## PLANNING COMMISSION STAFF REPORT

August 17, 2023

**AGENDA ITEM:** Planning File No. **MAJ-23-0007**, a sketch plan review of the Major Site Plan application for a proposed fifty-four (54) unit affordable, multi-family residential development.

**LOCATION:** 602 Galena Street / Lots 13 through 21, Block 3, Frisco Townsite

### **Bulk Standards (§180-6.23):**

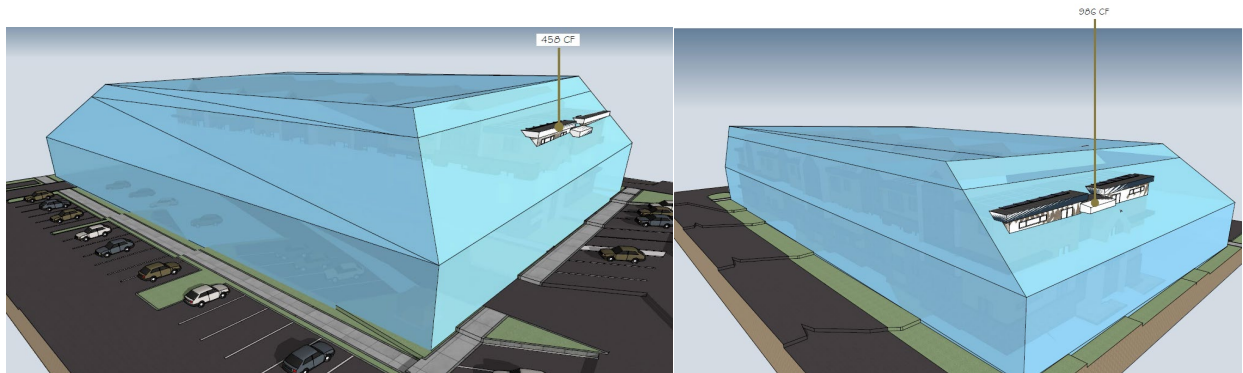
Table 6-K of the UDC outlines bulk plane requirements. §180-6.23.3 of the UDC states that building forms may deviate from this standard and project beyond the bulk plane if they do not exceed maximum building height and provide substantial architectural relief, with Planning Commission approval. The Affordable Housing Development incentives allow bulk plane encroachments up to the ratio of 500 cubic feet per 10,000 square feet of lot area. The application materials show 1,444 cubic feet of bulk plane encroachments, where 1,574 cubic feet is allowed. The application is meeting this requirement only if building height is met.

Staff requests the Planning Commission provide the applicant feedback regarding if they think that the bulk plane encroachments provide substantial architectural relief.
